Access Compliance Report Public Rights-of-Way (Pedestrian Signals)

Main Street: **BEACH_BLV** Cross Street: **CHAPMAN_AVE** Location: **NE**

ADA ID: **SGRK210928152748** Signal Type: **One Push Button-APS** Overall Compliance: **No** Severity Scores: **BTN 1: 25** **BTN 2: N/A** **No BTN: N/A**

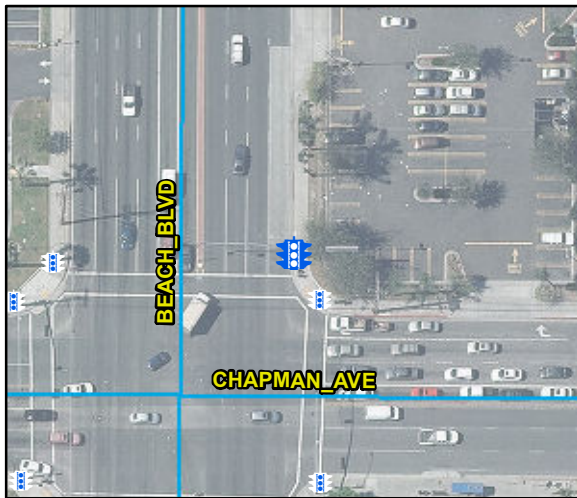
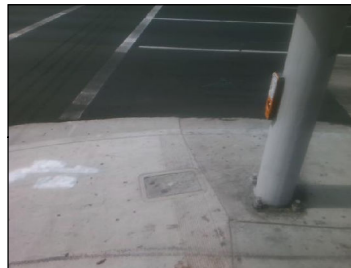
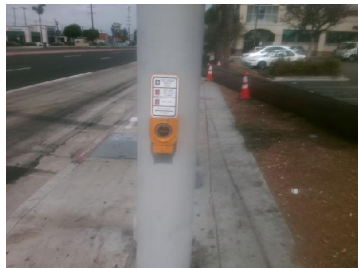
Possible Solutions: Replace Signal Push Button With APS Button. Remove & Relocate Sign.

OC Std/PROW: MUTCD 4e.08, R404.2, R404.3
